# ***3 Volt Intel<sup>®</sup> Advanced+ Boot Block Flash Memory***

***28F800C3, 28F160C3, 28F320C3, 28F640C3***

***Specification Update***

Order Number: 297938-014

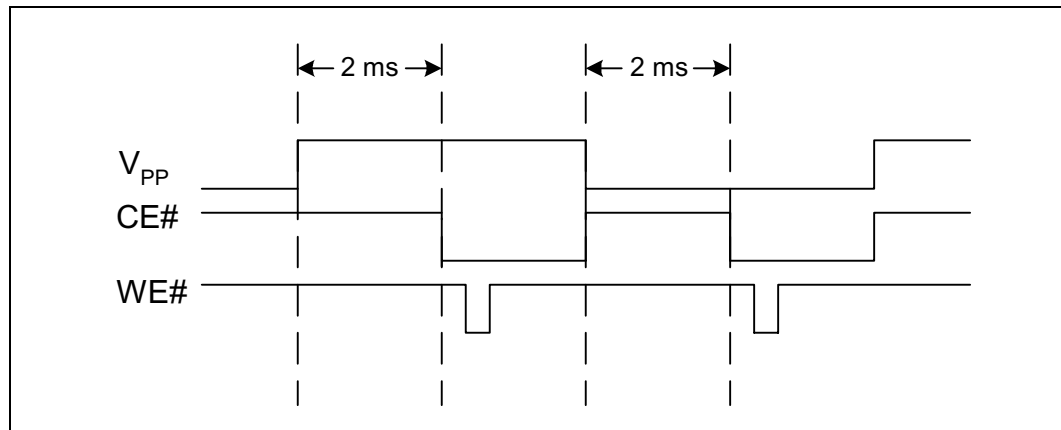
**Problem:** The 0.18 $\mu$ m 28F320C3xC devices can unintentionally reset under certain conditions where  $V_{pp}$  toggles.

**Implication:** When the reset occurs, any command being executed is interrupted and the flash switches to read array mode.

- 1) Tie  $V_{PP}$  to  $V_{CC}$ ;
- 2) If the third and fourth digits on the top side FPO mark (third line) is equal or greater than “23”, then  $V_{CC}$  may be set from 2.7v to 3.3v.  $V_{CC}$  must not exceed 3.3v
- 3) Set  $V_{pp}$  to a static high or static low level as shown here; and

4) Wait 2 ms after a  $V_{PP}$  transition to access the flash device, as shown here.

Figure 1. Workaround Placement

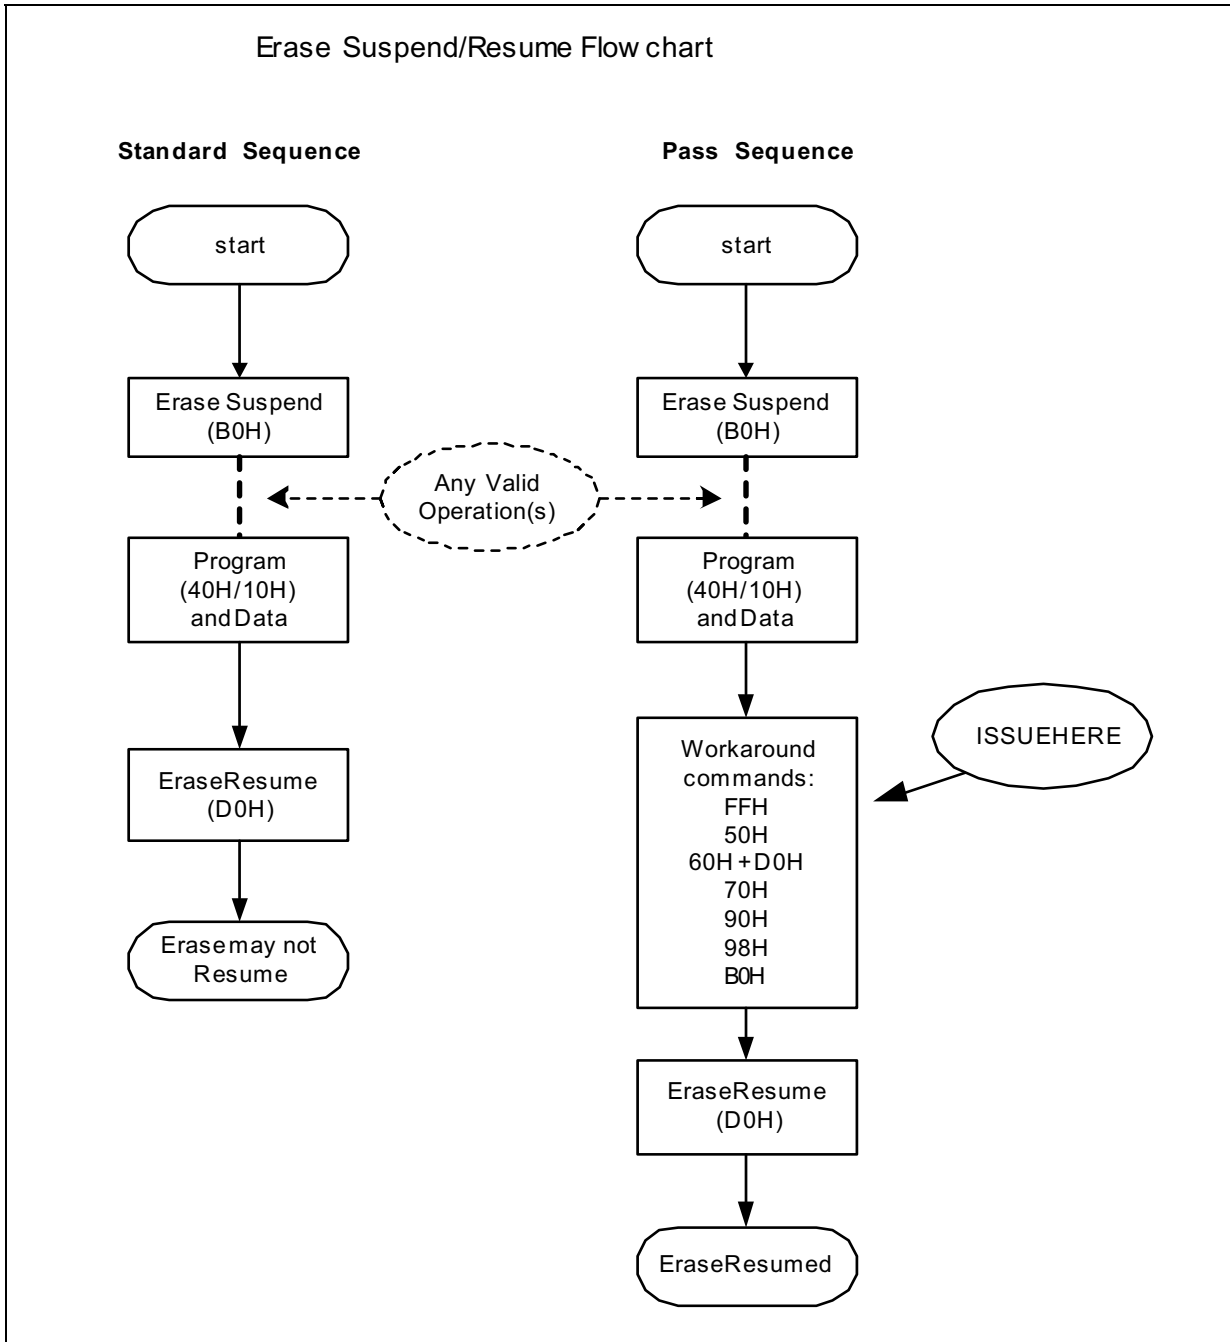
**Problem:** On the 0.18µm 28F160C3xC devices, a design anomaly was discovered. During an Erase-Suspend operation, if the Program (40H/10H) sequence is executed, under limited conditions the proceeding Erase Resume command (D0H) may not actually resume the device. No customers have reported failures in product applications. Customers who use any version of FDI (Intel Flash Data Integrator) software will not see this issue. If the Read Array command is issued prior to the Erase Resume command, users will not see the issue (typical in XIP applications).

**Implication:** The Resume Command (D0H) may be ignored by the device and will not correctly resume. The device will appear to remain in suspend (via status register). After a reset of the flash device the status register will clear. This failure has been recreated in a lab environment only.

1. If FDI (Intel Flash Data Integrator) software is used, users will not see the issue.
2. During an Erase-Suspend (B0H), user must issue any of the following commands after issuing the Program (40H/10H) and data sequence but before issuing the Erase-Resume (D0H) command.

**5. 28F160C3xC and 28F640C3xC Lock/Unlock/Lock-Down Operation**

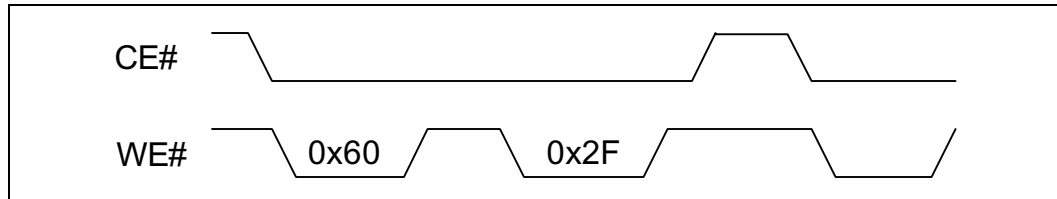
**Problem:** On the 16Mb and 64Mb 0.18µm devices, if CE# is deasserted after any block lock operation and before the next write sequence, the part may perform the same operation on additional blocks. (See waveform below.)

**Implication:** When CE# is deasserted after performing a block lock operation to a specific block and prior to the next write sequence, other blocks may perform the same operation.

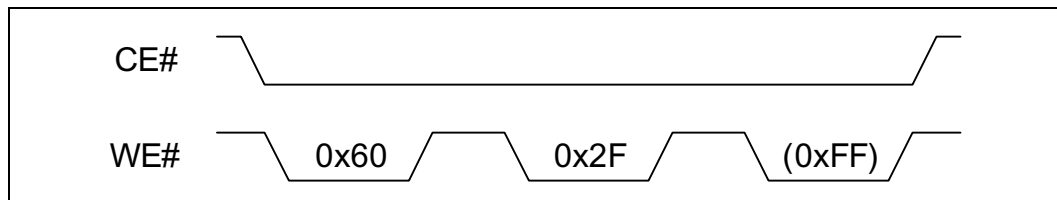
Immediately after performing a block lock, unlock, or lock-down operation, perform a valid write sequence before chip enable (CE#) is deasserted.

- 1) Assert CE# and toggle WE# to write the block lock setup command (0x60).
- 2) Toggle WE# a second time to write the confirm command (lock = 0x01; unlock = 0xD0; lock-down = 0x2F).
- 3) Toggle WE# a third time (ex: 0xFF- Read Array) before CE# is deasserted. (See waveform below.) Any other valid write sequence will also work (i.e., 0x90 - Read Configuration, 0x40 - Program, 0x20 - Erase).
